# GOVERNMENT/INDUSTRY AERONAUTICAL CHARTING FORUM Instrument Procedures Group April 22, 2008 HISTORY RECORD

## FAA Control # <u>08-01-280</u>

<u>Subject</u>: Minimum Obstruction Clearance Altitudes Depicted on Standard Instrument Departures (SIDs)

# ZEFFR THREE DEPARTURE (RNAV)

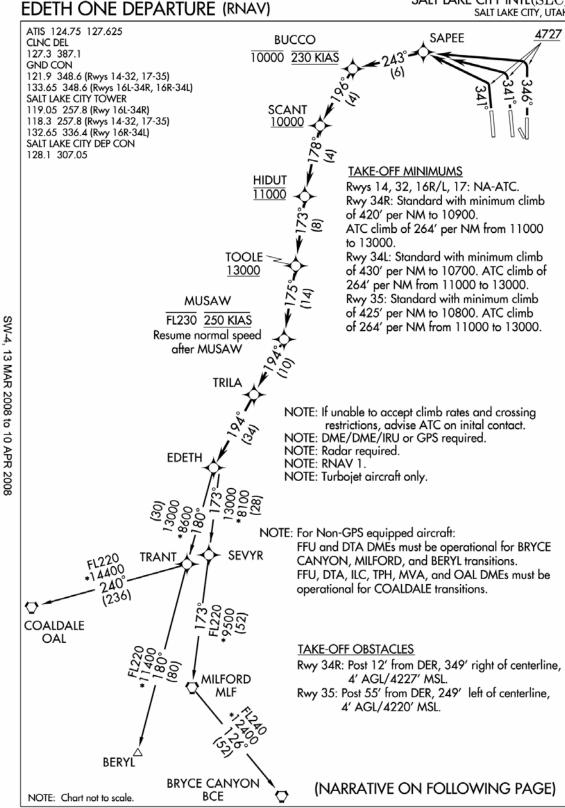
**Background/Discussion:** FAA Order 8260.46C, Departure Procedure Program, paragraph 10(f)(1), Charting Minimum Altitudes, requires that SIDs (both conventional and RNAV) must depict minimum altitudes for obstruction clearance; and, where appropriate, any required minimum ATC altitudes. Where these differ, documentation of both minimum altitudes is required on the 8260-15 form. Appendix 5 (Non-RNAV DP's) and Appendix 6 (RNAV DP's) of this Order require that SIDs accommodate ATC and obstruction clearance requirements by documenting the ATC altitude followed by the altitude required for obstruction clearance. Charting agencies must depict the obstruction altitude as a minimum crossing altitude (MCA). An example of the application of this requirement may be seen on the attached ZEPHR THREE RNAV SID at Reno, NV (RNO).
